SERVICE BULLETIN – ATOM80

Exhaust support plate

1P04-0021_01 - Assembly procedure for exhaust support bracket

CODE: AT186

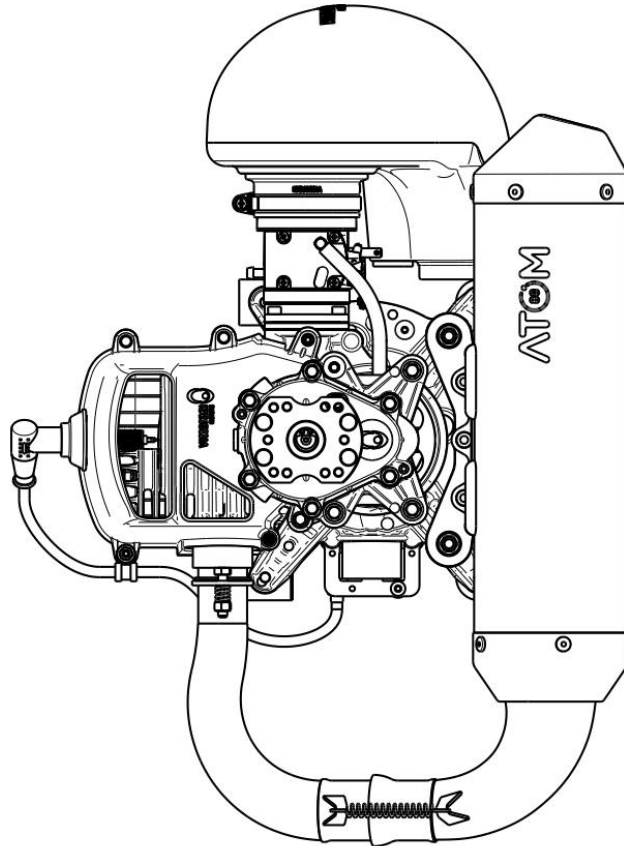
It has been found on some engines that the exhaust plate code AT186 has broken after hours of operation. The plate has been reinforced: the geometry has been changed and the thickness has been increased to give greater resistance. Material and fastening are unchanged.

1.

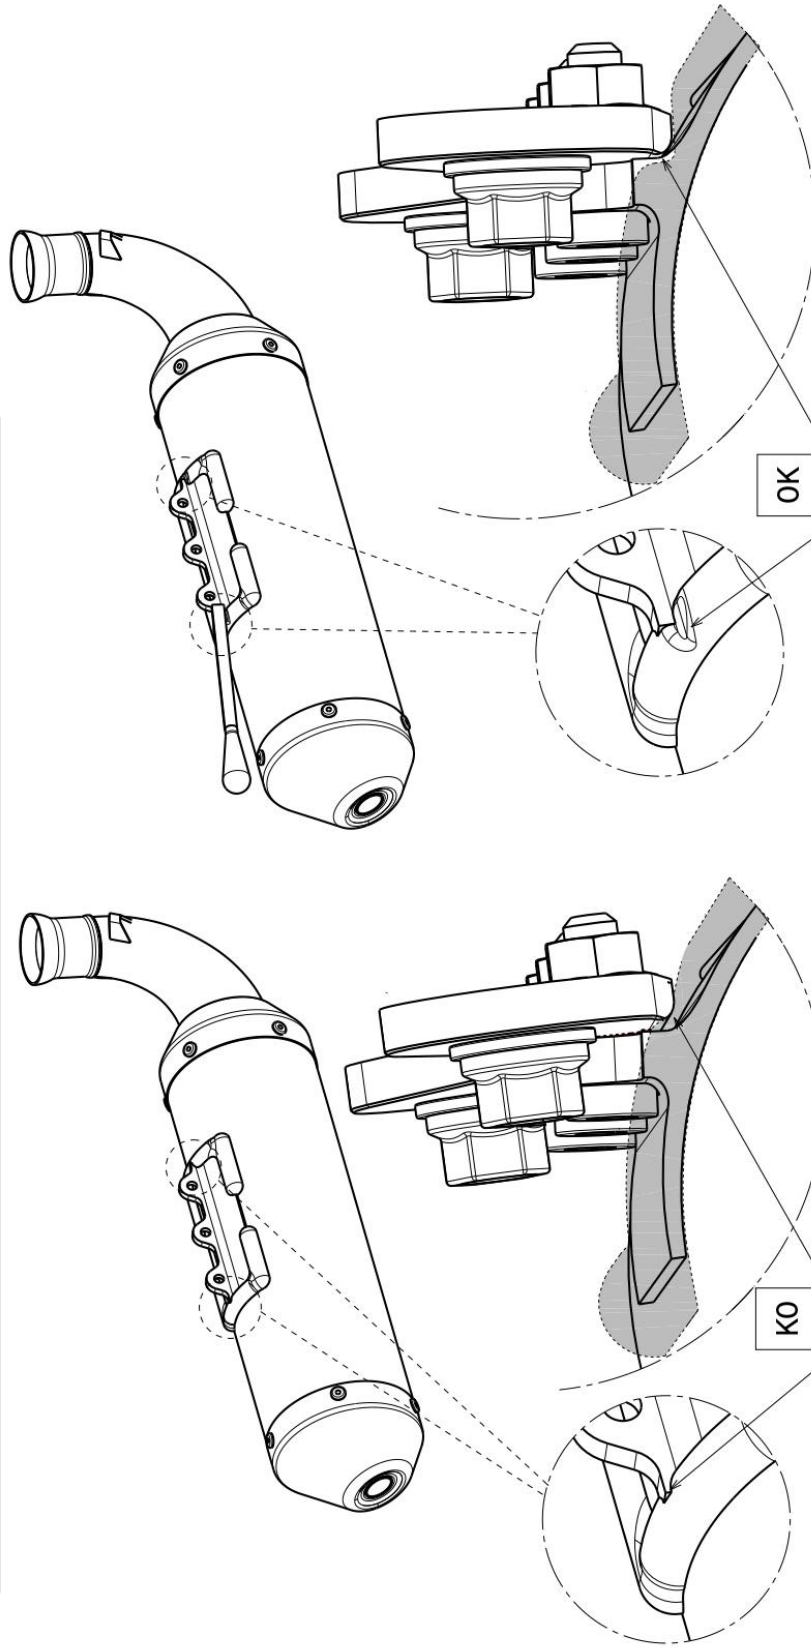
Check the welding in the indicated areas.
If you notice interference between the plate and the welding,
remove the weld excess with a file.

- No contact between plate and welding
- No gap between plates

- Interference between plate and welding
- Imperfect contact or gap between plates

Weld filings may be required in the area of contact with the plate.

2. Pre-assemble plate without tightening the screws and nuts.

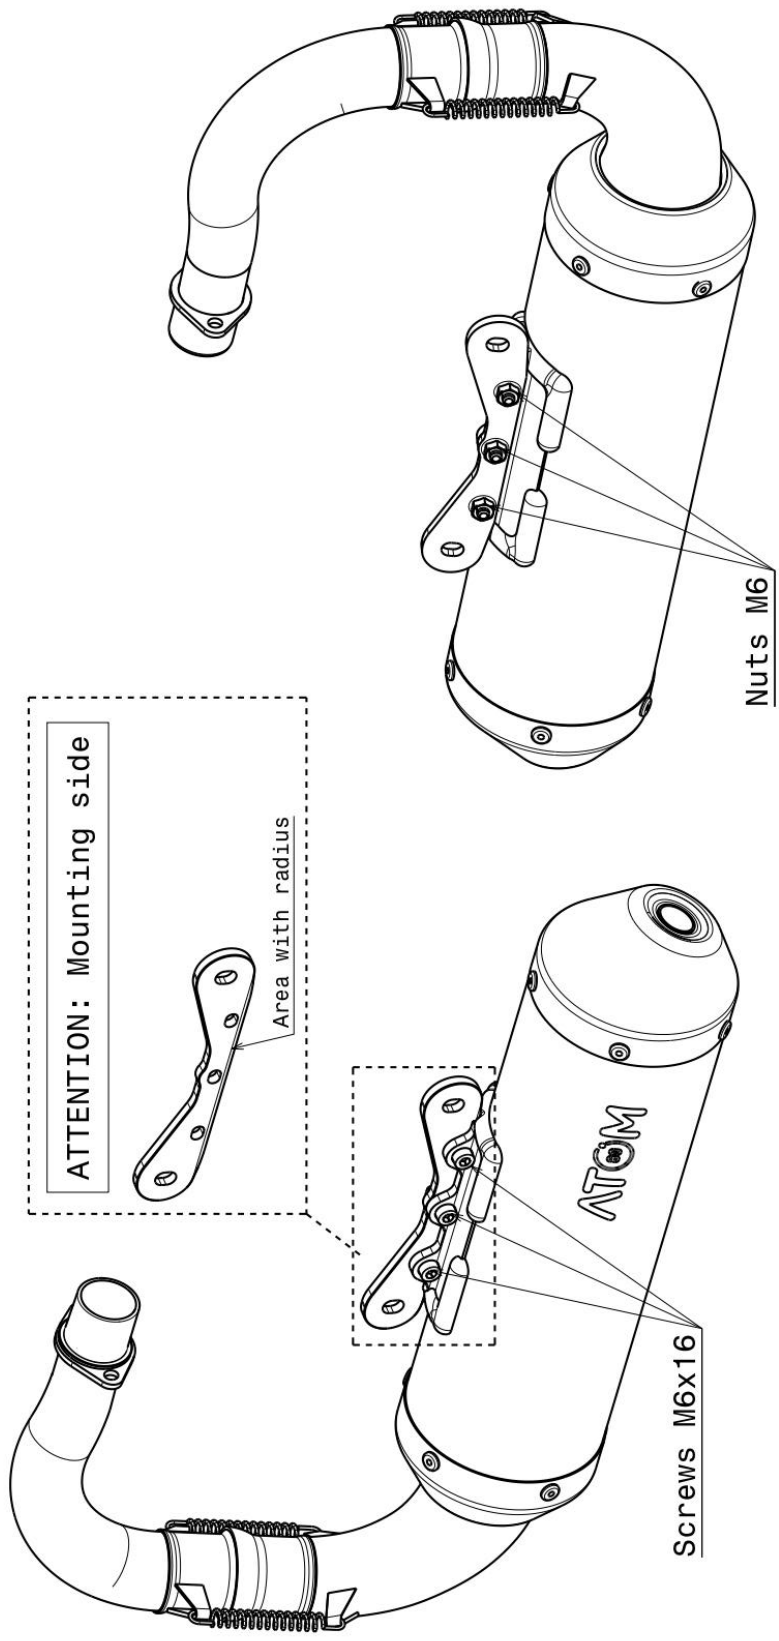
- IMPORTANT:**
- use new nuts and screws provided with the kit
 - pay attention at the mounting side of the plate

4. Check that the exhaust joint is well aligned

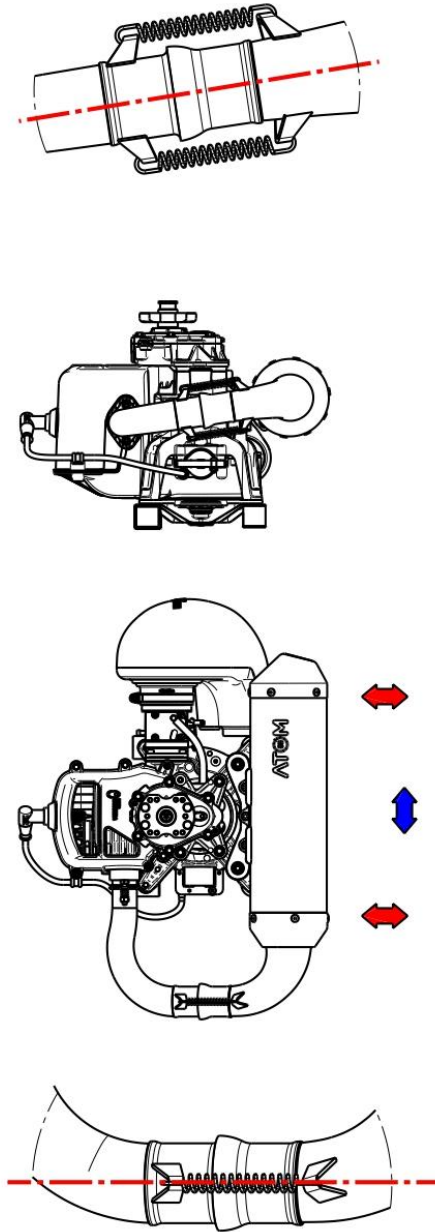
5. When the joint is aligned tighten screws and nuts
